# FL1.1

AC

# Service Information

### 3. New XICOR

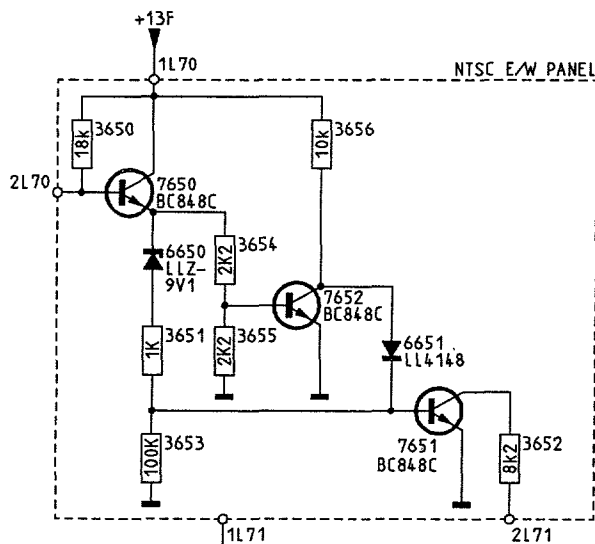
During production position 7137 of the small signal panel has been modified from a X2404 to an ST24C04B1 (4822 209 52316). This modification was introduced in week 9207.

Several other components have also been modified during this modification, some of which were introduced earlier.

Removed

Positions 3256 and 3257

Modified

Positions 3122 and 3123 (8k2) 4822 051 10822

Added

Positions 3287 and 3288 (10K) 4822 051 10103

Positions 6256 and 6257 (LL4148) 4822 130 80446

Positions 6135 (4702) 4822 051 10471

The addition of position 6135 must occur if 7137 is modified to an ST24C04B1 and may not be present if an X2404 is used.
